BULLETIN NUMBER:
IB23-J-001

REPLACEMENT LONG BLOCKS & INSTALLATION TIPS

AFFECTED VEHICLES

Figure 1

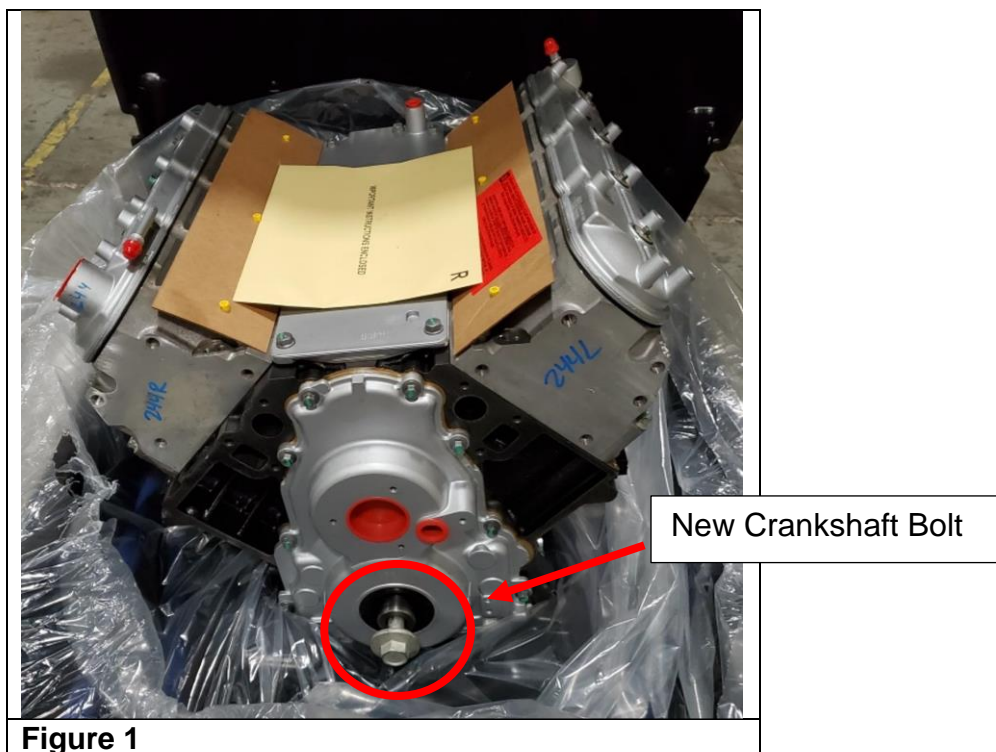
NOTE: A required ***new*** replacement bolt for the crankshaft pulley ***is*** included with the remanufactured long block assembly. (See Figure 1.)

Figure 2

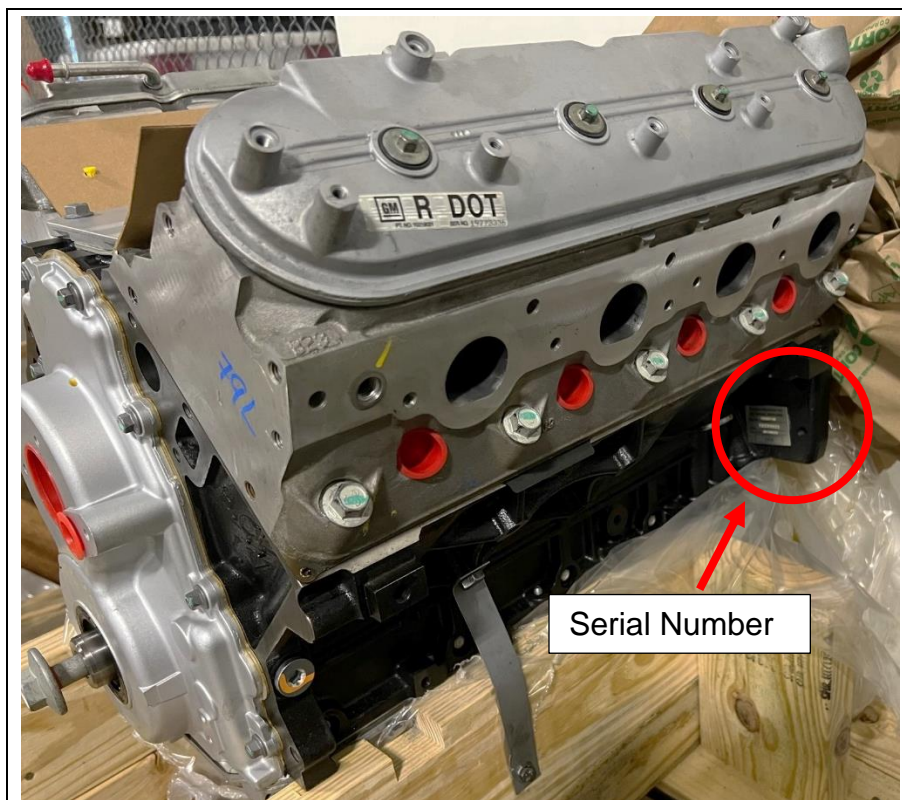
On remanufactured 6.0L gasoline engines the location of the engine serial number that needs to be programmed into the ECM prior to repair completion has changed. Refer to Figure 2 for the location of this serial number.
